SUBJECT: Duke Energy Corporation
Catawba Nuclear Station, Units 1 and 2
Docket Nos. 50-413 and 50-414
NRC Generic Letter 2004-02, "Potential Impact of Debris Blockage on
Emergency Recirculation During Design Basis Accidents at Pressurized-
Water Reactors"

Response to Request for Additional Information

Enclosure 1
Responses to Staff Request for Additional Information Identified on February 9, 2006
Catawba Nuclear Station Units 1 and 2
Generic Letter 2004-02

Figure 5-1
Catawba LBLOCA Expected Beginning and End of Life Sump pH Response

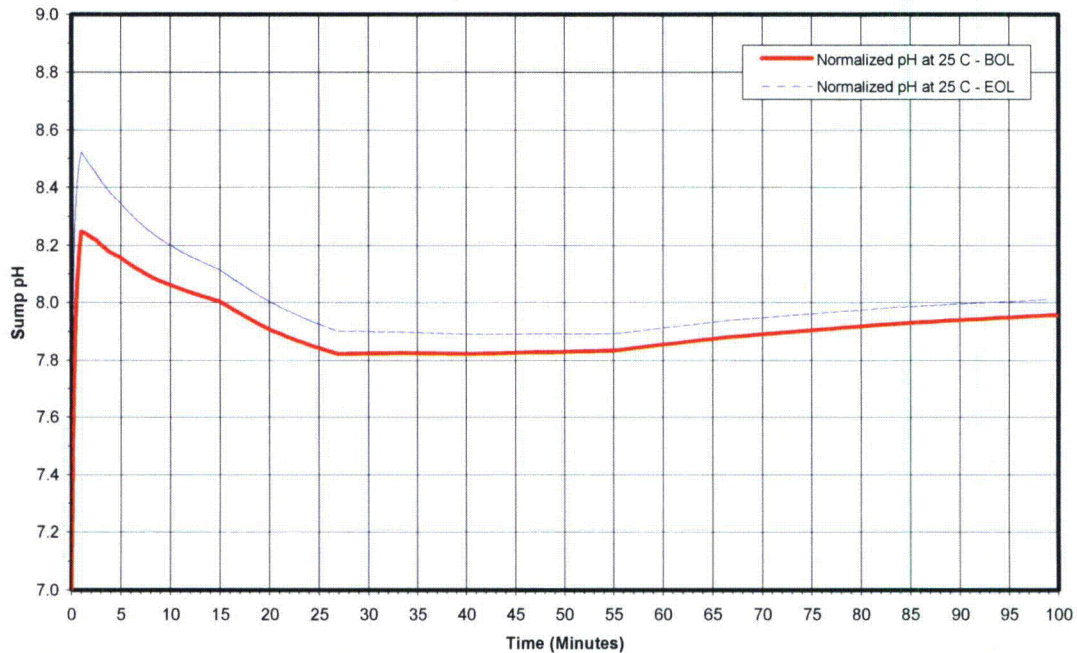
Provide the expected containment pool pH during the emergency core cooling system (ECCS) recirculation mission time following a LOCA at the beginning of the fuel cycle and at the end of the fuel cycle. Identify any key assumptions.

An analysis was performed to document how the ECCS sump pH was affected by both Beginning-of-Life (BOL) and End-of-Life (EOL) boron concentrations in the reactor coolant inventory. The EOL scenario, consisting of much lower concentrations of boron in the reactor coolant inventory, yields a higher sump pH profile than the same analysis for the BOL assessment. Figure 5-1 shows the time-dependent sump pH profile for both BOL and EOL cases, normalized to 25 °C.

The Catawba ECCS sump pH analysis shows that by 2 hours after LBLOCA initiation all of the water from the RCS, Refueling Water Storage Tank (FWST), Cold Leg Accumulators (CLAs), and the ice melt from the Ice Condenser will be in the sump. Continuing nitric acid and hydrochloric acid production due to irradiation of the water/air mixture and of the electrical cable insulation/jacket material inside containment will be a long term contributor to the pH value of the sump. In order to address the impact of this effect, a sensitivity analysis was performed and showed that when the time range is expanded beyond 2 hours, there is an insignificant change in the ECCS sump pH.

Figure 11-1
Integrated Prototype Test Setup

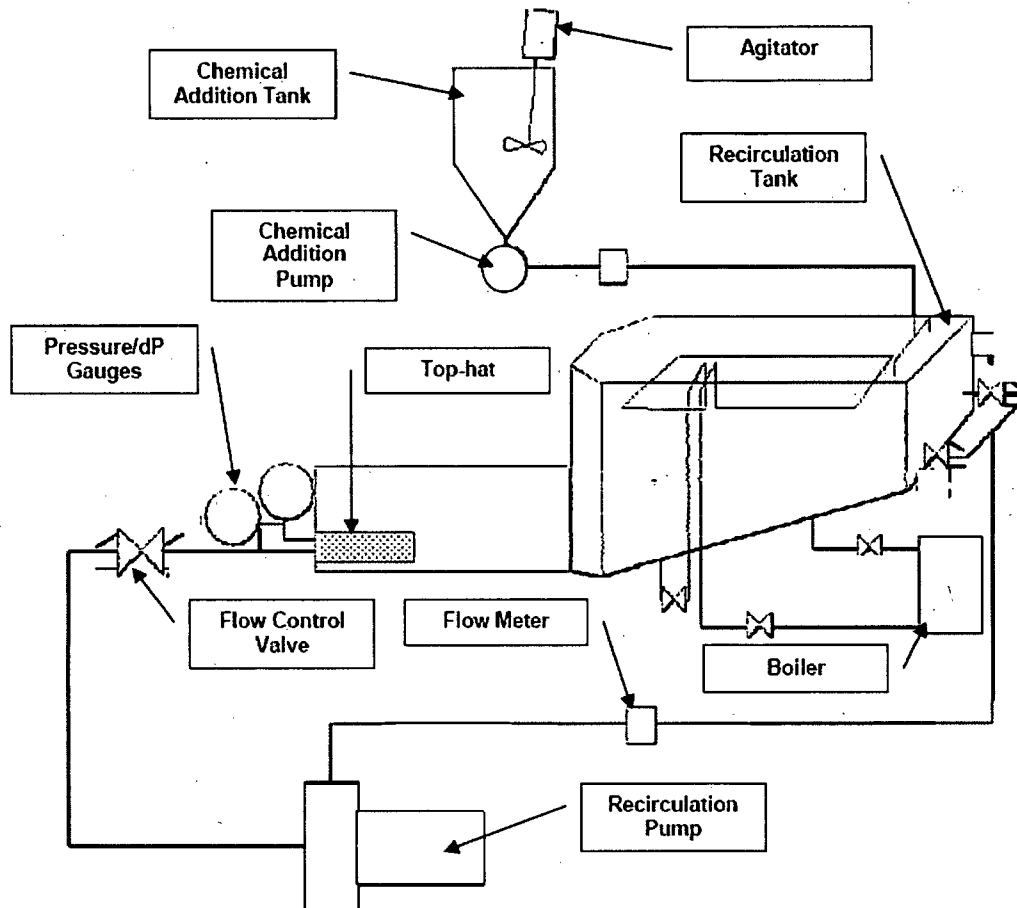
Provide a detailed description of any testing that has been or will be performed as part of a plant-specific chemical effects assessment. Identify the vendor, if applicable, that will be performing the testing. Identify the environment (e.g., borated water at pH 9, deionized water, tap water) and test temperature for any plant-specific head loss or transport tests. Discuss how any differences between these test environments and your plant containment pool conditions could affect the behavior of chemical surrogates. Discuss the criteria that will be used to demonstrate that chemical surrogates produced for testing (e.g., head loss, flume) behave in a similar manner physically and chemically as in the ICET environment and plant containment pool environment.

A 36-inch long prototype top-hat module was utilized in the IPT test loop. This length is representative of the population of top-hat modules available on the McGuire Unit 1 and 2 modified strainers (24 inch, 30 inch, 36 inch and 45 inch) and dimensionally similar to the population of top-hat modules available on the Catawba Unit 1 and 2 modified strainers. All other top-hat parameters (e.g., base plate, mesh size, diameter) on the test prototype module are identical to those installed in the McGuire and Catawba ECCS sumps, including the bypass eliminator feature.

Figure 11-1 below shows the physical IPT rig setup.
